Special Bulletin

SP16-311B

Rev B This revision replaces previous releases

DIRECT LIGHT COVER LENS SECUREMENT

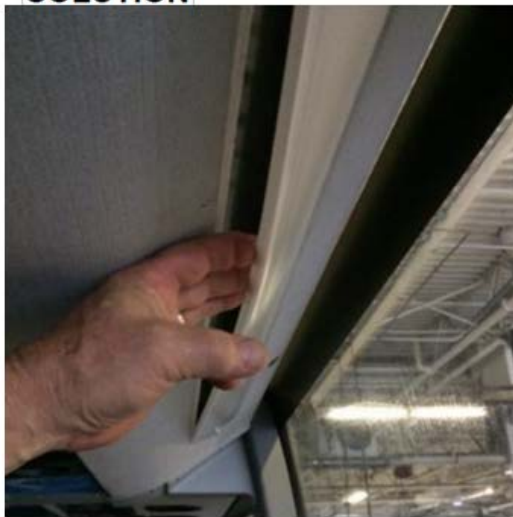
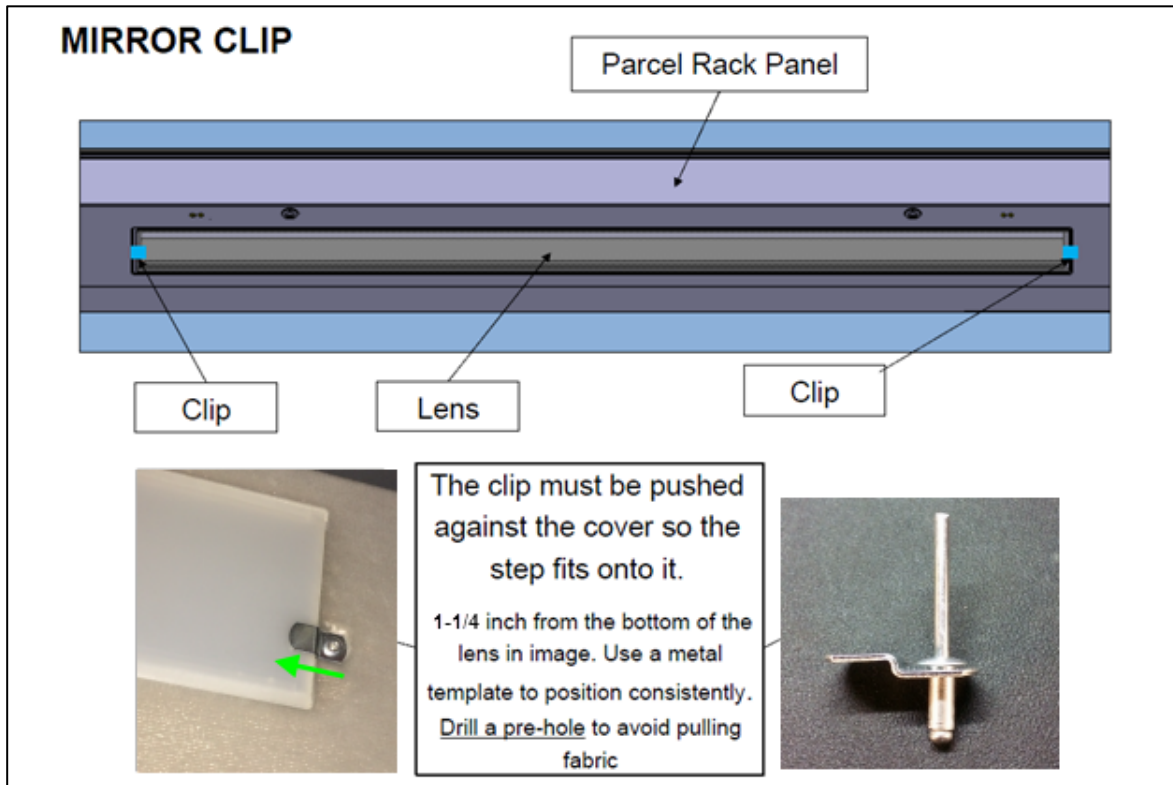
On the vehicles affected by this bulletin, add two clips to secure the direct light lenses, 13 lenses per vehicle.

- Protect the passenger seats under the lens by installing a drape to collect debris from drilling and bulletin activities.

November 02, 2016 Material changed to "Z" clip
